### **URBAN DESIGN COMMITTEE**

### **URBAN DESIGN COMMITTEE STAFF REPORT**

### **URBAN DESIGN COMMITTEE STAFF REPORT**

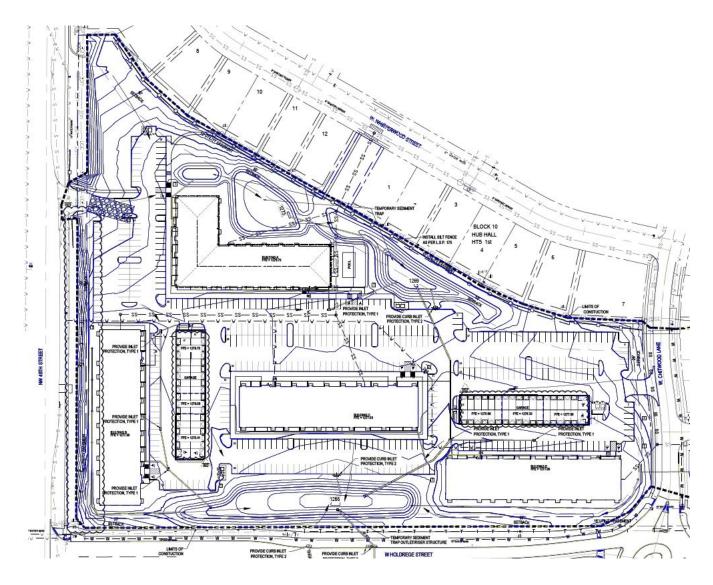
- *Parking lot islands* Double rows of parking shall not exceed forty consecutive stalls (twenty per row) without an internal island break.
- *Parking lot interior landscaping* For parking lots that exceed 200 stalls, interior landscaping shall account for at least ten percent (10%) of the total parking lot square footage.

- *Parking lot trees* For parking lots 6,000 square feet or greater, there shall be planted within the paved area a minimum of one (1) shade tree, plus one (1) additional shade tree for every 6,000 square feet of parking lot paving. Each required internal landscape island for a double row of parking shall have at least one (1) shade tree. Those required shade trees not required to be planted within double row islands may be planted along the perimeter of the parking lot within eight feet (8') of the paved area. Each tree planted along the perimeter of the parking lot may be used for one-half (1/2) of the required total of shade trees required within the paved area.

**Compatibility per Staff Analysis:** The parking lot shown in the renderings does not appear to fully meet the above standards.

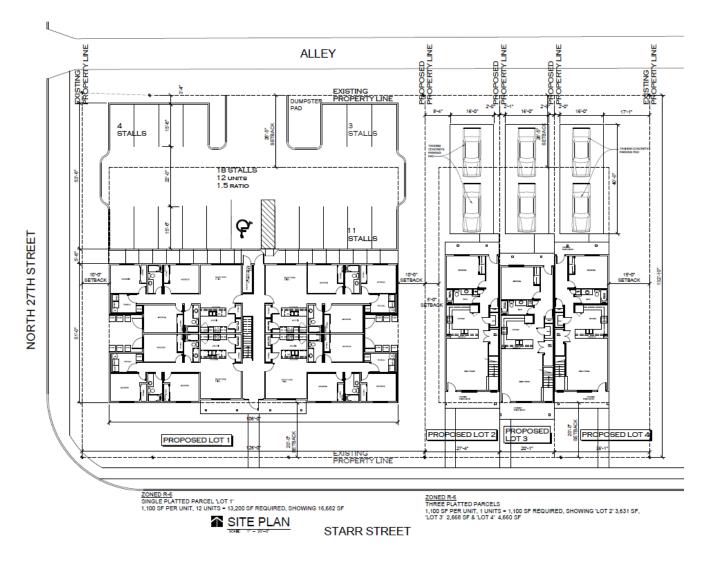
2. Trees in addition to any others required elsewhere shall be planted within five (5) feet of a parking area at the rate of one tree for every six (6) parking spaces.

**Compatibility per Staff Analysis:** Only two of the three required trees are being shown in the parking lot for the 12-plex. The tri-plex shows a total of six stalls, which would typically require one tree. However, the property is being replatted so that each unit sits on its own property. In that scenario, each property would only have two parking stalls and would not be subject to this standard.

3. Parking areas of four or more stalls shall be screened from adjacent properties. Fences may be used for screening in rear yards.

**Compatibility per Staff Analysis:** While this standard is somewhat vague in regards to screening of parking lots, the Design Standards for Screening and Landscaping for which this property is also subject to will require that the entire length of the north edge of the parking lot for the 12-plex (adjacent to the alley) be screened up to three feet (3') in height. Again, the requirements for the triplex come down to whether this would be considered a single parking lot of six stalls or three parking lots of two stalls each. For the former, a screen would be required along the east edge to provide a buffer against the adjacent residential.
